**DRAINAGE LETTER
FOR
STERLING RANCH ROAD
CROSSING OF SAND CREEK**

Engineering Review

**EPC Planning & Community
Development Department**

PCD-ENGINEERING REVIEW COMMENTS
IN BLUE BOXES WITH BLUE TEXT

BRIDGECOR STEEL BOX
STERLING RANCH ROAD- CO SPRINGS
COLORADO SPRINGS, CO

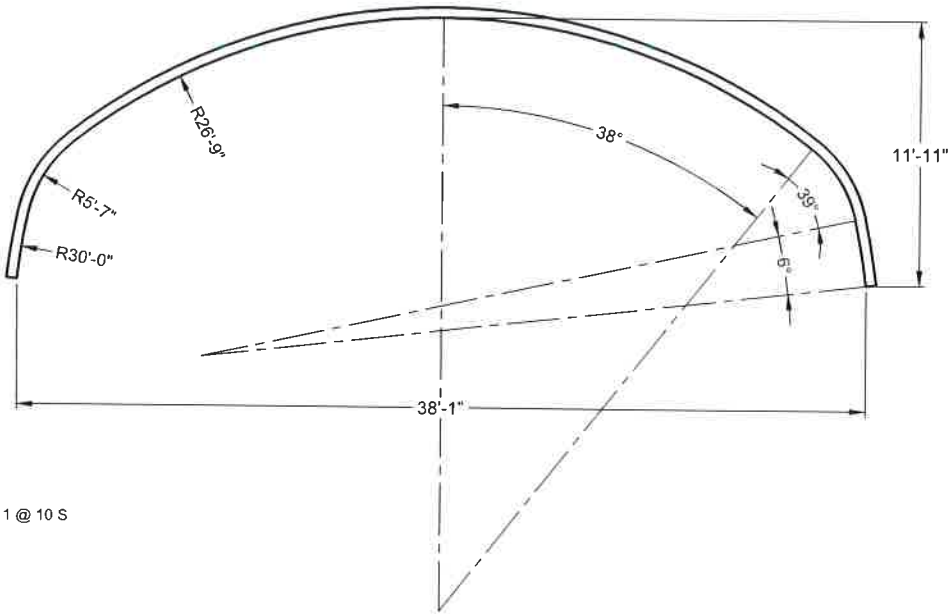
provide revised version
